Date Created : **2009/04/03**
Date Issued On : **2009/04/14**
PCN# : **Q2091404**

DESIGN/PROCESS CHANGE NOTIFICATION -- FINAL

Change Type Description: Assembly Process, Lead Finish Composition, Package Change (Lead Frame), Package External Dimension

FROM	TO
Bottom View:

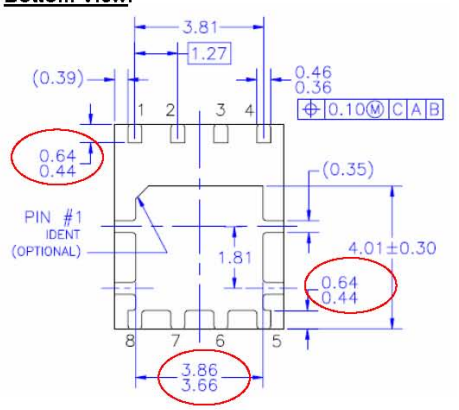
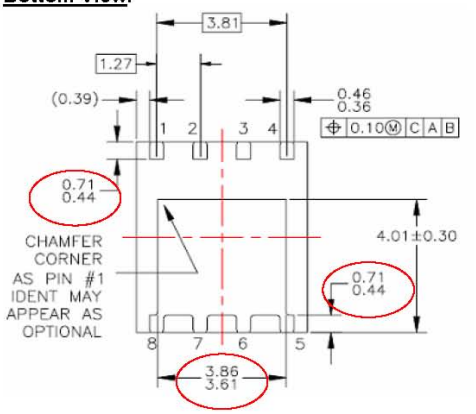
Lead Length (Pin 1-4): 0.44 – 0.64 mm Lead Length (Pin 5-8): 0.44 – 0.64 mm Exposed Pad length: 3.66 – 3.86 mm Notes: a) Pin #1 Identification Optional b) Tie-bar location and pitch specified	**Bottom View:**

Lead Length (Pin 1-4): 0.44 – 0.71 mm Lead Length (Pin 5-8): 0.44 – 0.71 mm Exposed Pad length: 3.61 – 3.86 mm Notes: a) Chamfer Corner as Pin#1 Identification may appear as optional b)Tie-bar location not specified
Side View:

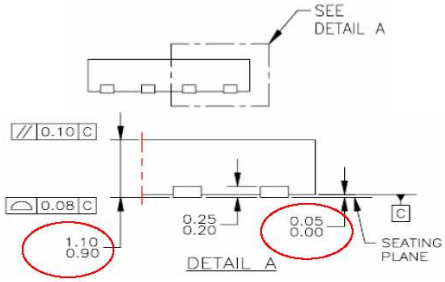
Package height: 1.05 mm Stand-off height: 0.00 – 0.06 mm	**Side View:**

Package height: 0.90 - 1.10 mm Stand-off height: 0.00 – 0.05 mm Exposed leads height: 0.20 – 0.25 mm Additional Information for Punch Singluation:

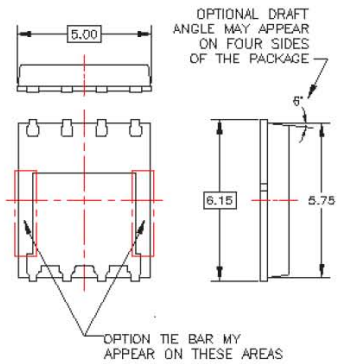
Notes: - Optional Draft Angle may appear on four sides of the package (6°) - Optional tie bars may appear on these areas (max tie bar protrusion: 0.15 mm) - Molded Package length: 5.75 mm
